**DELAWARE RIVER JOINT TOLL BRIDGE COMMISSION
EXECUTIVE OFFICES
2492 RIVER ROAD
NEW HOPE, PENNSYLVANIA 18938-9519**

**CONTRACT NO. T-668A, CAPITAL PROJECT 0301A
THE SCUDDER FALLS BRIDGE REPLACEMENT PROJECT**

ADDENDUM NO. 7

RESPONSES TO CONTRACTOR INQUIRIES SUBMITTED TO THE
COMMISSION
FROM NOVEMBER 2, 2016 THROUGH NOVEMBER 15, 2016
INQUIRIES BY POTENTIAL BIDDERS

On Sheet 51 of 62 in Package A – Part 5, the SECTION A-A is revised as follows.

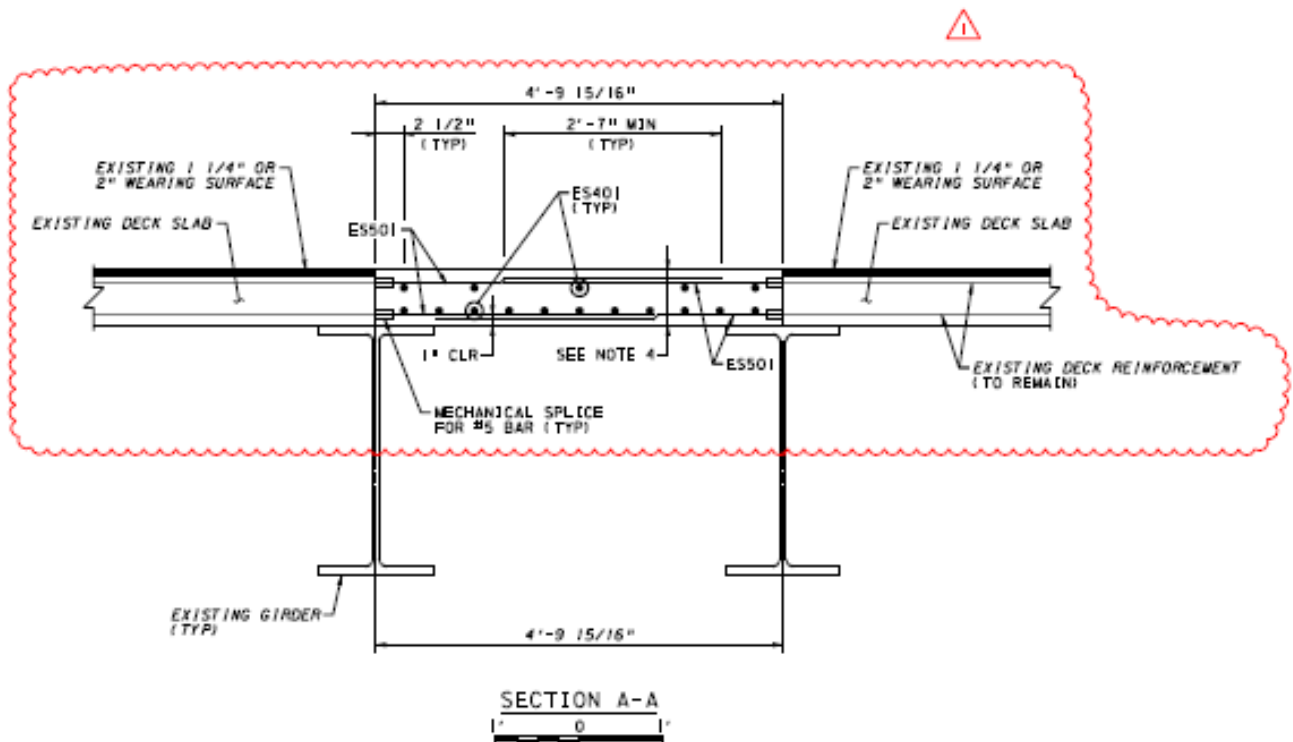
Inquiry 176: Refer to S-36221 Sheets 8 & 51 and S-36222 Sheets 7 & 48. The typical existing sections show an overlay for the riding surface on the bridge decks. The details for the temporary median decks show matching the existing deck thickness. However, the temporary decks actually need to be thicker to match the grade of the adjacent overlay. Please advise how this grade differential is to be handled.

***Response 176:** S-36221: On Sheet 51 of 62 in Package A – Part 5, SECTION A-A will be revised to show the existing wearing surface. The proposed top of temporary deck will be shown at an elevation equal to the top of wearing surface. The 9 1/2" MAX temporary deck thickness presently shown in SECTION A-A accounts for the thickness of the wearing surface. Refer to Notes 2 and 4 on Sheet 51 of 62. Note that the revisions to the temporary deck slab reinforcement will be made to allow for adequate reinforcement bar development.

On Sheet 51 of 62 in Package A – Part 5, the Notes will be revised as follows.
